IDAP REPORT – SECTION 4.55(1A) MODIFICATION

Property:	16 Florence Street STRATHFIELD DA 2013/43/3
Proposal:	S4.55(1A) modification application to change the roof form of an approved detached studio.
Applicant:	J Michael
Owner:	J. Michael
Date of lodgement:	6 May 2020
Notification period:	13 May 2020 to 27 May 2020
Submissions received:	Nil
Assessment officer:	N Doughty
Zoning:	R2-Low Density Residential - SLEP 2012
Heritage:	Yes – Heritage Item No. I136
Flood affected:	Yes
Is a Clause 4.6 Variation Proposed:	No
RECOMMENDATION OF OFFICER:	APPROVAL

Figure 2: Approved western elevation of studio above existing garage.

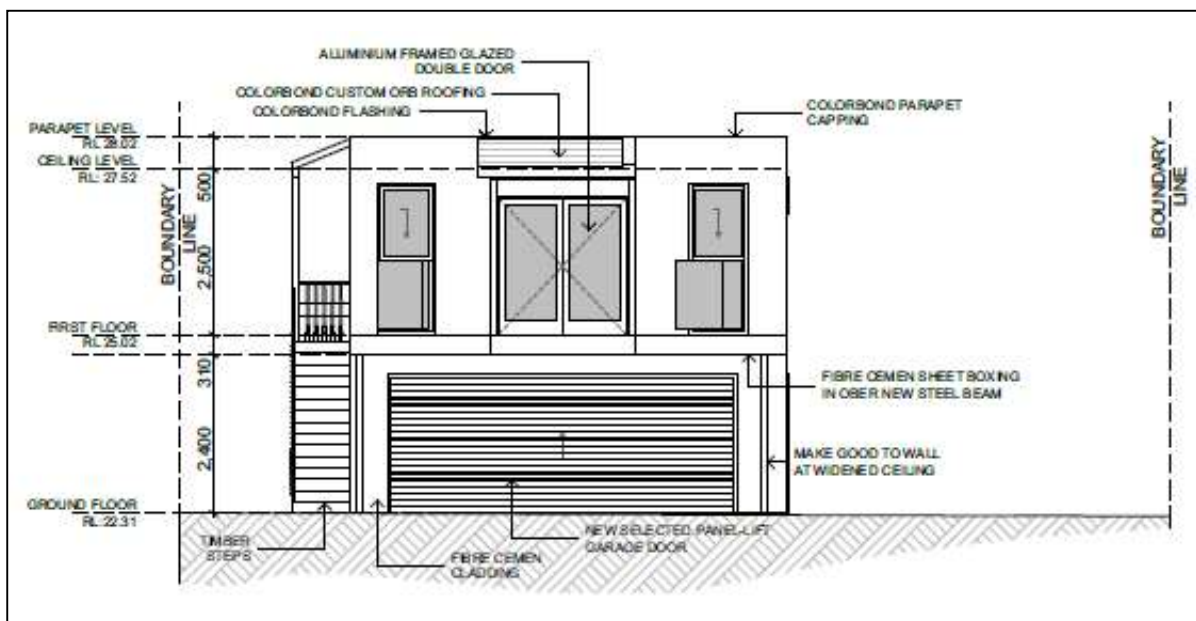
Council has received an application seeking modifications to an approved first floor studio above the existing garage at the rear of the site. The specific elements of the modifications sought are as follows (Figures 2 to 4):

- Amend the roof style of the studio above the garage from flat to gable;
- Amend the schedule of colours and external finishes to reflect the modified roof form;
- Replace the solid wall side elevations of the studio balcony to horizontal louvres;
- Increase the bathroom from 2.55m² to 4.25m² and inclusion of a shower; and
- Modification of Condition No. 28 regarding tree pruning to reflect the current canopy conditions of the on-site trees.

"In May 2020, the applicant has sought to modify this consent again, due to practical reasons as the garage is located under trees, it seeks to use a pitched roof rather than a flat roof. It is behind the dwelling within the rear yard. It is unlikely that it will not impact the item and the adjoining item due to its location and that the roof is similar to the heritage item. I agree with the applicant that it will better fit into the setting. From the limited view from the street I agree that on heritage grounds the proposal is likely to be an improvement from the original flat roof design."

Comments: The proposed amendment to the roof form of the approved studio from flat to gable results in the building height of the studio increasing from 5.75m to 7.28m. Whilst the change in roof style increases the height of the studio/garage structure, the downward slope and siting of the structure to the rear of the site minimises the visibility from the streetscape. Further, it remains compliant with the maximum building height control.
